Addendum #01 for RFP947800-01

Project Name: DAS CC Wallace Building Demolition

DAS RFP #: 947800-01 DAS Project #: 9478.00

Date: 6/13/2025

1.4.1 (ADDENDUM 01) Attachment A - Conceptual Schedule

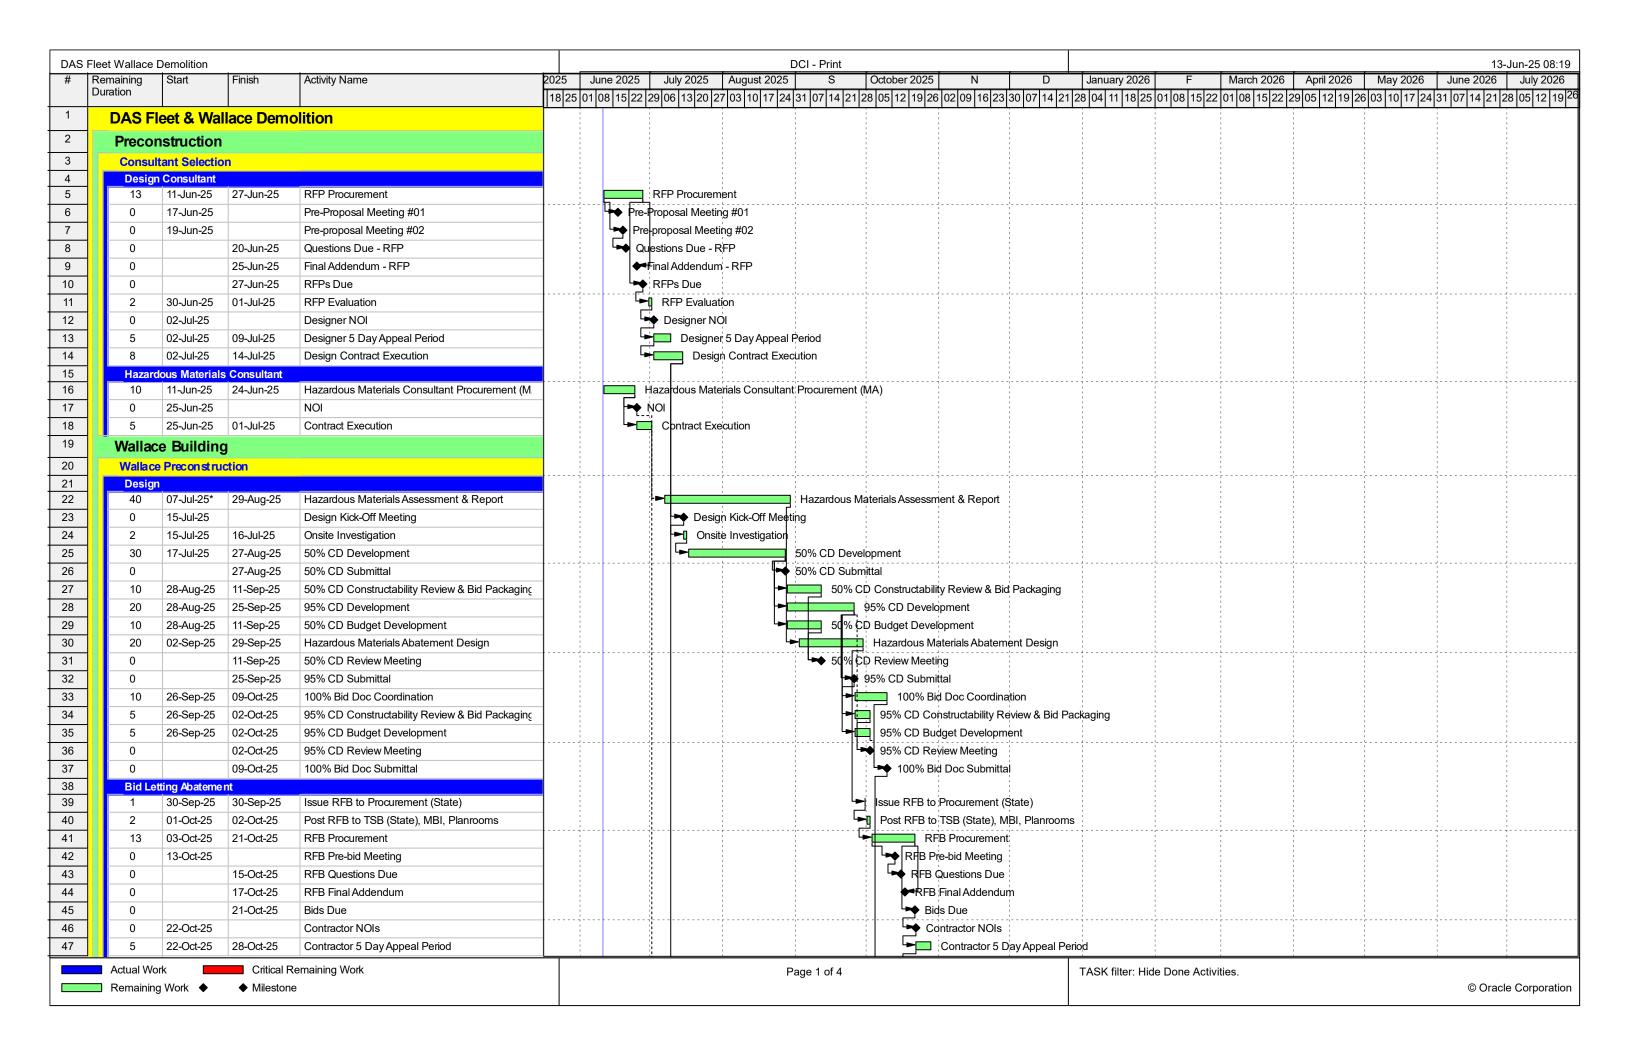
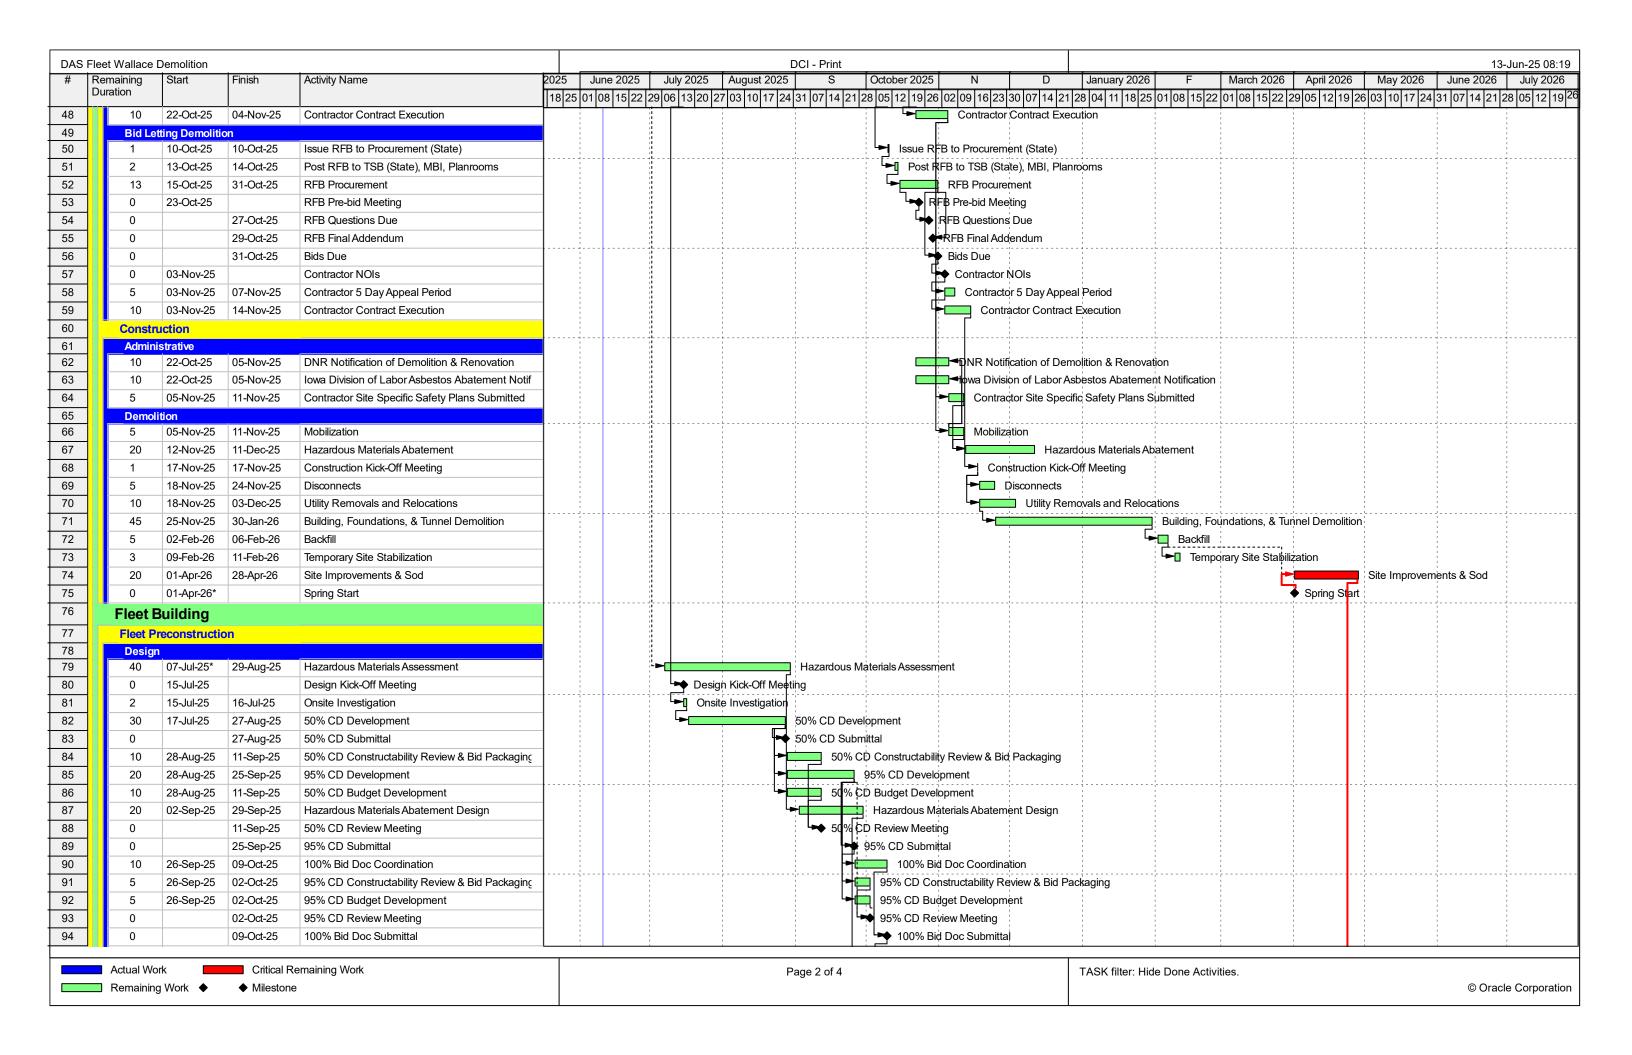
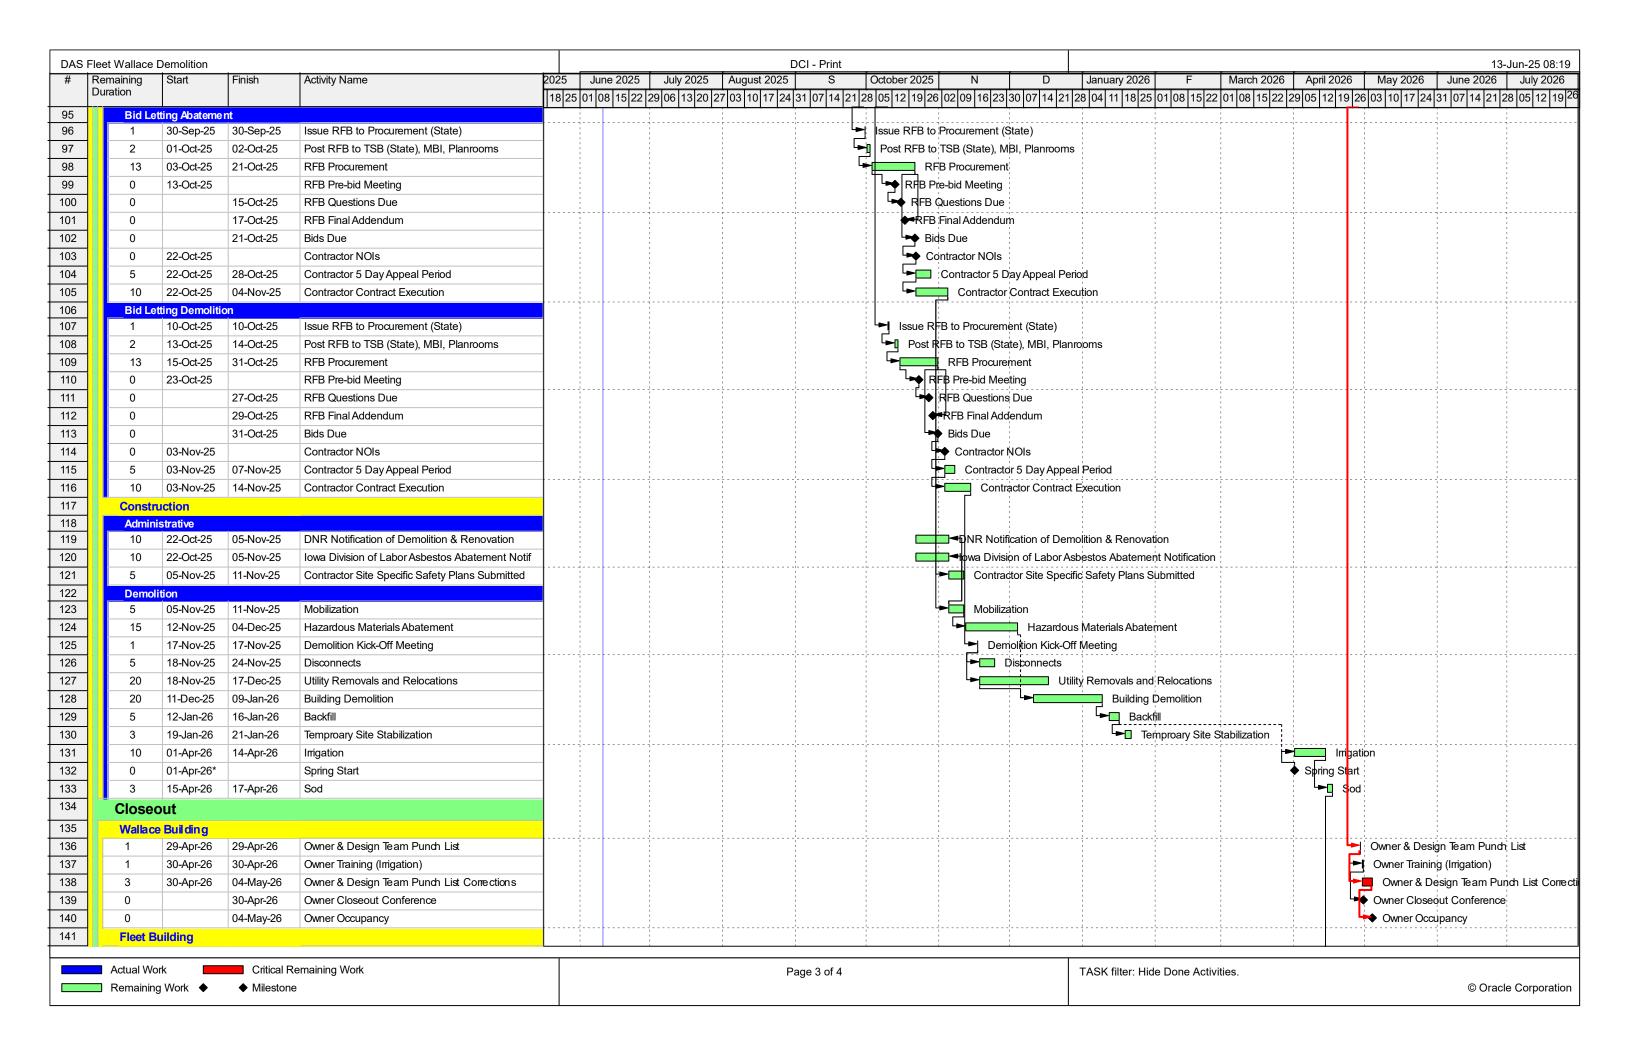
- A. Section 1.2 Schedule will remain the same, including the incorporation of the Fleet Building. See the REVISED Attachment A – Conceptual Schedule for further detail.
- B. The pre-proposal conference will not include a tour of the interior of the Fleet Building. Access to the Fleet Building will be provided during the design process.
- C. It is anticipated that the Wallace Building and Fleet Building will be bid as two separate projects with two separate sets of bid documents.
